Committee of Experts on the Transport of Dangerous Goods and on the Globally Harmonized System of Classification and Labelling of Chemicals

Recommendations made by the Sub-Committee at its sixty-second, sixty-third and sixty-fourth sessions and pending issues: Explosives and related matters: Review of tests in parts I, II and III of the MTC

Proposed changes to the Koenen test specifications

Transmitted by the experts from the United Kingdom of Great Britain
and Northern Ireland and the United States of America

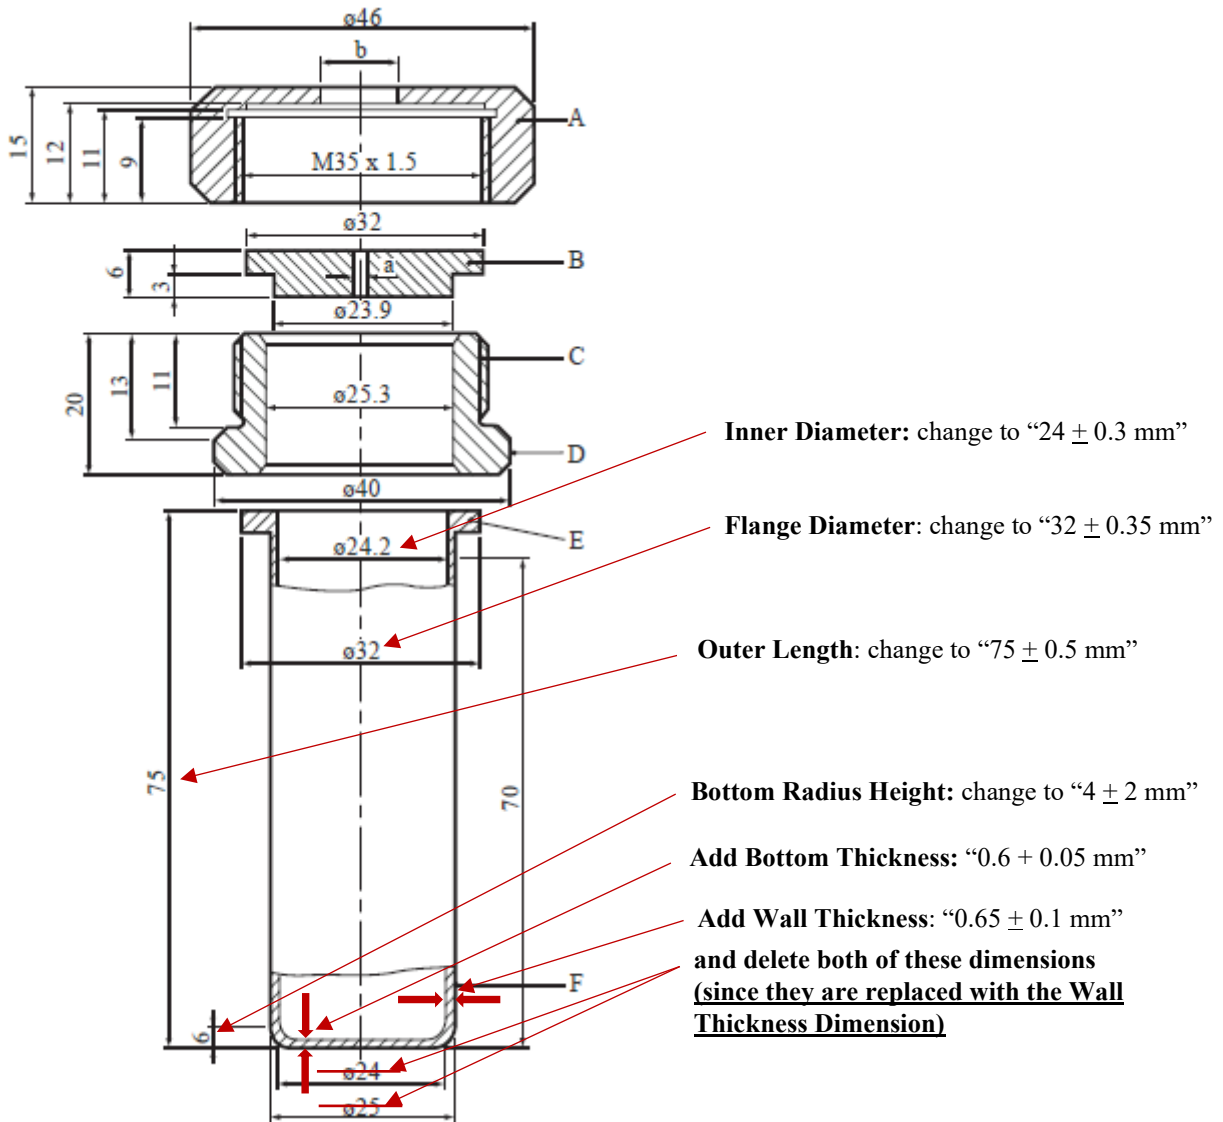
(e) Incorporate the following tube tolerance amendments into Figures 11.5.1.1, 12.5.1.1, 18.6.1.1 and 25.4.1.1. The underlined text is explanatory. Maintain the “key” below the figures.

- (a) The mass of the tubes shall be ~~26.5 ± 1.5 g~~ 27.5 ± 3 g, tubes to be used in one test sequence shall not differ in mass by more than 1 g;
- (b) The length of the tubes shall be 75 ± 0.5 mm;
- (c) The wall thickness of the tubes measured 20 mm from the bottom of the tube shall be ~~0.5 ± 0.05 mm~~ 0.65 ± 0.1 mm; and
- (d) The bursting pressure as determined by ~~quasi-static~~ dynamic load through an ~~incompressible fluid~~ liquid shall be 29 ± 4 MPa. The dynamic bursting pressurization rate is defined as a continuous and rapid pressure rate (i.e., 5-35 MPa in less than 0.5 seconds).

Figure A12.2.1: Burst Pressure Apparatus setup

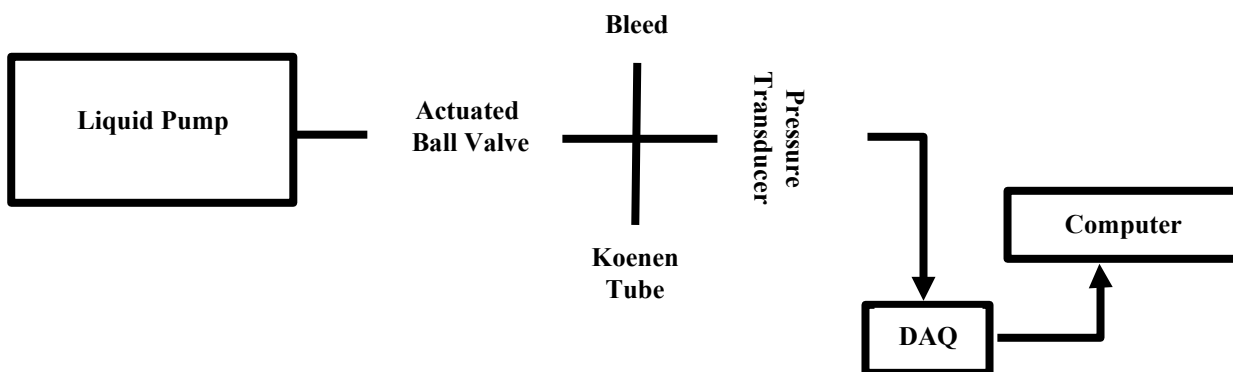
- (a) Burst pressure apparatus (figure A12.2.1) designed to completely purge Koenen tubes of all air and apply pressures of 35 MPa or greater using a non-corrosive liquid. The apparatus is equipped to accept a pressure transducer.

- A12.2.3.1 The burst pressure testing apparatus is set up to purge air from the tube and introduce the test liquid. The pressure transducer and data acquisition system are attached (see Figure A12.1) and tested to verify proper functioning and capability to accurately measure and record pressures above the maximum burst pressures specified in 11.5.1.2.1 (d), 12.5.1.2.1 (d), 18.6.1.2.1 (d), or 25.4.1.2.1 (d) of this *Manual*.

- A12.2.3.3 The modified orifice plate is connected to the burst pressure apparatus and placed in a protective area, then connections verified against leaks. The entire system is purged of air, then the vacuum valve is closed and examined for constant pressure. The actuated ball-valve is closed to prevent premature pressurization of the Koenen tube, after which the supply line to the closed valve is charged with the pump to approximately 35 MPa. The ball-valve is opened remotely and gauge pressure at which tube bursts is recorded.
